## PLAN CHANGE REQUEST 2

DATE: 03/03/2022 PERMIT NO./REF NO: E-20-0612

1. PROJECT: Furrucci Junior High Addition ADDRESS: 3213 Wildwood Park Drive
2. OWNER: Puyallup School District EMAIL: vandelj@puyallup.k12.wa.us
3. DESIGN ENGINEER: Sitts & Hill Engineers, Inc. EMAIL: rickh@sittshill.com
4. CONTRACTOR: Pease & Sons, Inc. EMAIL: brandon@peaseandsons.com
5. ORIGINATOR OF REQUEST:  
☒ OWNER ☒ DESIGN ENGINEER ☒ CONTRACTOR ☐ CITY OF PUYALLUP
6. DOES THIS REQUEST REQUIRE A DEVIATION FROM AN EXISTING CITY STANDARD? ☐ YES ☒ NO
7. IF YES, PLEASE SUBMIT AN ALTERNATIVE METHODS FOR CONSTRUCTION MATERIALS REQUEST APPLICATION (AMR).
8. IF NO, PLEASE COMPLETE THE FOLLOWING:
9. APPROVED CIVIL PLAN SHEET NUMBERS AFFECTED: C7.01, C7.02
10. WHAT PART OF THE CITY AND/OR DEVELOPMENT INFRASTRUCTURE IS BEING AFFECTED?  
☒ ROAD ☐ STORM ☐ WATER ☐ SANITARY ☐ GRADING ☐ EROSION CONTROL
11. DESCRIBE THE CHANGE BEING REQUESTED: (ATTACH ADDITIONAL INFORMATION AS NECESSARY)

Subject: Street Light Pole Base Conflict with Existing Conditions

**C7.01**

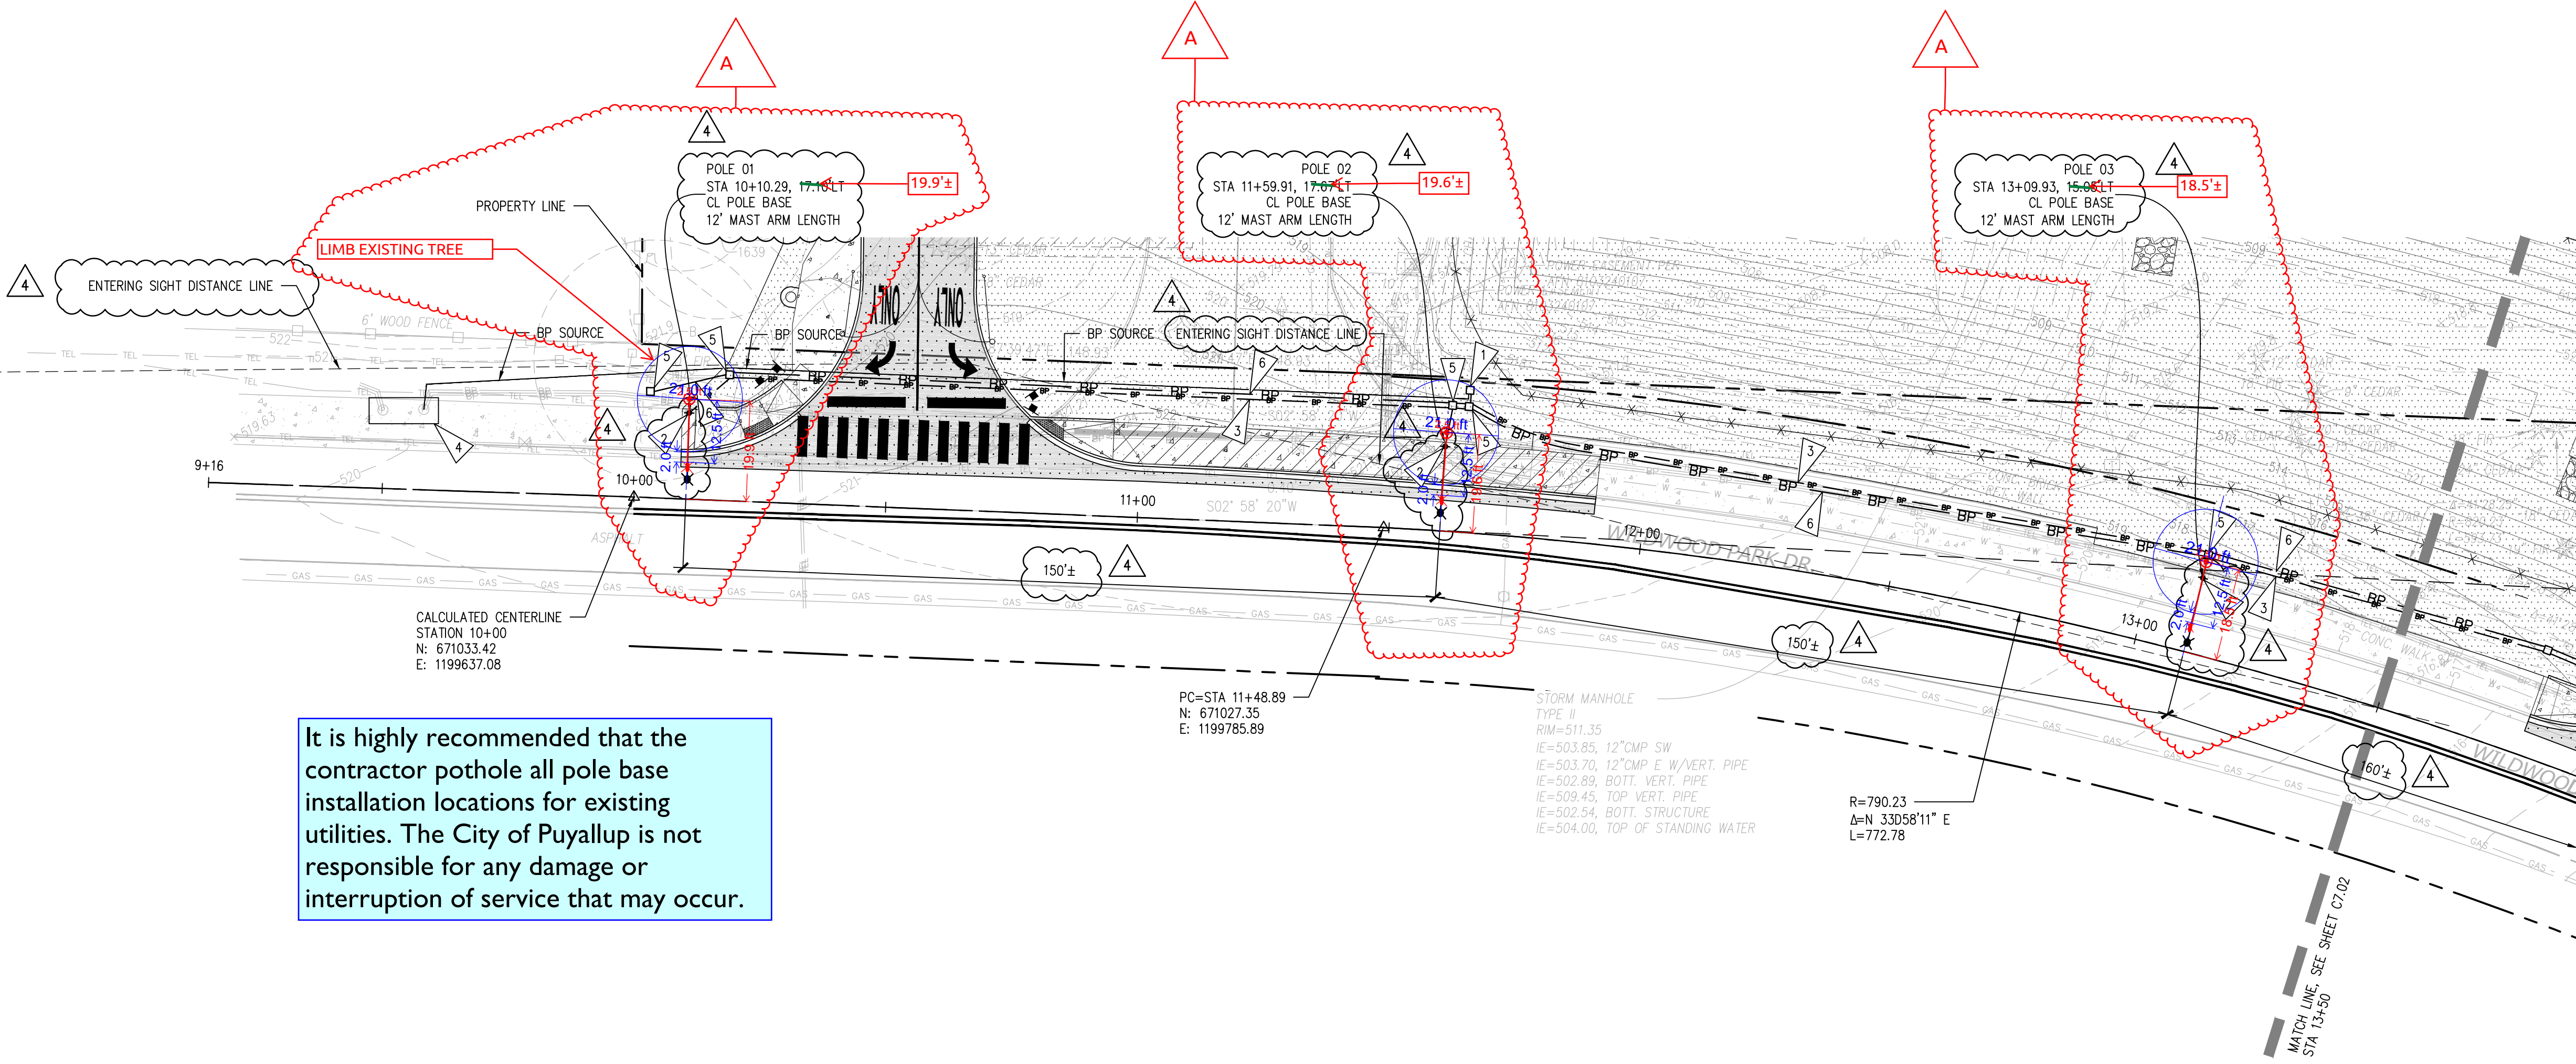
Correct the plan horizontal offset locations so that the pole base location is behind the back of walk versus in the walk. The revised locations comply with standard City detail 01.05.04 requirements on Sheet C7.04.

The six light poles have been laid out on site, and all bases conflict with existing conditions. Bases will conflict below grade with existing power mains, communication mains, water mains, and/or existing/future sidewalk. Please provide direction.

1. 12' mast arms.
2. Position the back of luminaire 2' from face of curb at specified stations.
3. Revise the pole base offset locations to comply with above and City requirements. Pole offset locations have been revised per the attached sheets C7.01 and C7.02.
4. If the existing fiber optic utility is in conflict with the proposed locations, relocate the fiber utility to avoid the pole locations.
5. Limb selected trees to comply with City requirements.

RFI 157 Proposed Light Pole Locations  
R. Hand 02-24-2022  
revised 03-09-2022
